SUBJECT: ISSUANCE OF AMENDMENT NO. 81 TO FACILITY OPERATING LICENSE
NO. NPF-8 REGARDING PRESSURE-TEMPERATURE LIMITS RELATING TO
GENERIC LETTER 88-11 - JOSEPH M. FARLEY NUCLEAR PLANT, UNIT 2,
(TAC NO. 77542)

AMENDMENT NO. 81 TO FACILITY OPERATING LICENSE NO. NPF-8 - FARLEY, UNIT 2

Amendment No. 81
License No. NPF-8

SAFETY EVALUATION BY THE OFFICE OF NUCLEAR REACTOR REGULATION
SUPPORTING AMENDMENT NO. 81 TO FACILITY OPERATING LICENSE NO. NPF-8
ALABAMA POWER COMPANY
JOSEPH M. FARLEY NUCLEAR PLANT, UNIT 2
DOCKET NO. 50-364

Figure 3.4-2 Farley Unit 2 Reactor Coolant System Heatup Limitations Applicable for the First 14 EFPY.

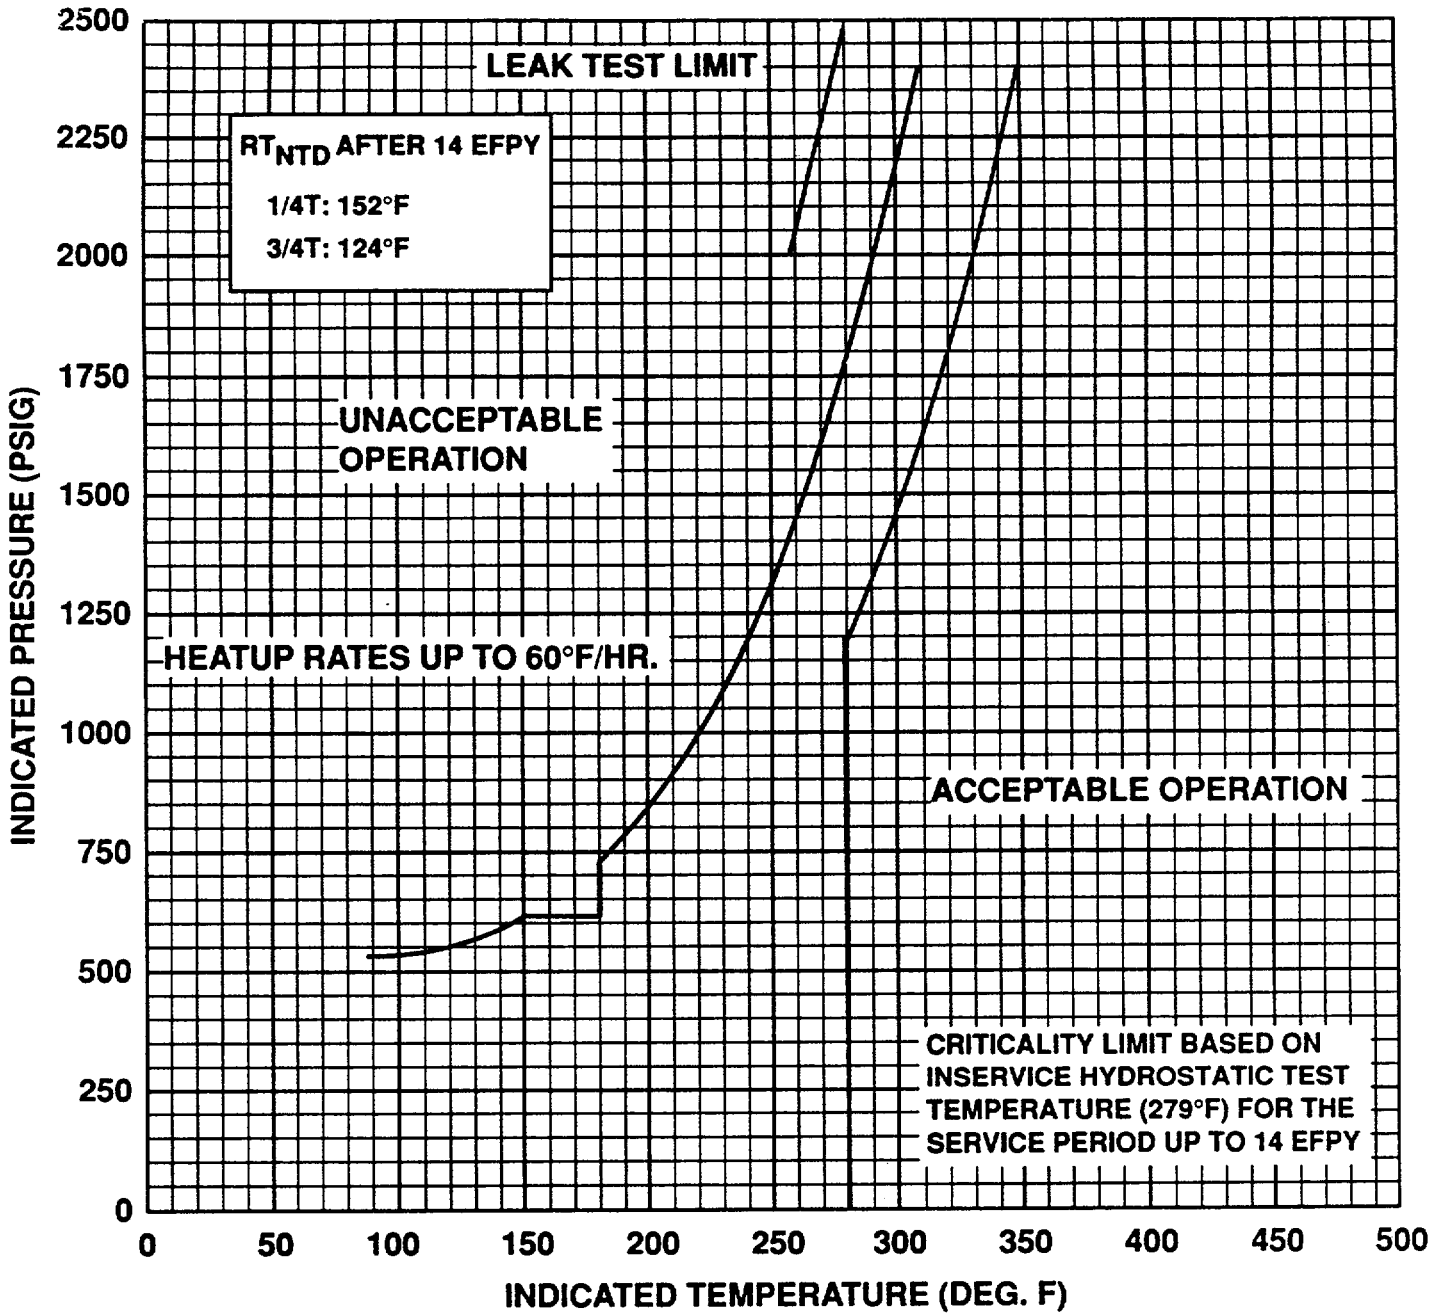
The amendment changes the Technical Specifications to provide heatup and
cool down curves applicable to the first 14 effective full power years
for the reactor.

The reactor vessel materials have been tested to determine their initial RT_{ndt} ; the results of these tests are shown in Table B 3/4.4-1. Reactor operation and resultant fast neutron (E greater than 1 MEV) irradiation can cause an increase in the RT_{ndt} . Therefore, an adjusted reference temperature, based upon the fluence and the nickel and copper content of the material in question, can be predicted using WCAP-12471 and the recommendations of Regulatory Guide 1.99, Revision 2, "Radiation Embrittlement of Reactor Vessel Materials." The heatup and cooldown limit curves of Figures 3.4-2 and 3.4-3 include predicted adjustments for this shift in RT_{ndt} at the end of 14 EFPY.

Finally, the 10CFR Part 50, Appendix G Rule which addresses the metal temperature of the closure head flange and vessel flange must be considered. This Rule states that the minimum metal temperature of the closure flange regions be at least 120°F higher than the limiting RT_{ndt} for these regions when the pressure exceeds 20 percent of the preservice hydrostatic test pressure (621 psig for Farley Unit 2). In addition, the new 10CFR Part 50 Rule states that a plant specific fracture evaluation may be performed to justify less limiting requirements. Based upon such a fracture analysis for Farley Unit 2, the 14 EFPY heatup and cooldown curves are impacted by the new 10CFR Part 50 Rule as shown on Figures 3.4-2 and 3.4-3.

The licensee calculated an ART of 152°F and 124°F at 1/4T and 3/4T, respectively, for the limiting material. The licensee's ARTs are more conservative than the staff's ARTs; therefore, they are acceptable. Substituting the ART of 149.5°F into equations in SRP 5.3.2, the staff verified that the proposed P/T limits for heatup, cooldown, and hydrotest meet the beltline material requirements of Appendix G to 10 CFR Part 50.

The staff concludes that the proposed P/T limits for the reactor coolant system for heatup, cooldown, leak test, and criticality are valid through 14 EFPY as the limits conform to the requirements of Appendices G and H to 10 CFR Part 50. The licensee's submittal also satisfies Generic Letter 88-11 as the licensee used the method in RG 1.99, Revision 2, to calculate the ART. Hence, the proposed P/T limits may be incorporated into the Farley, Unit 2, Technical Specifications.
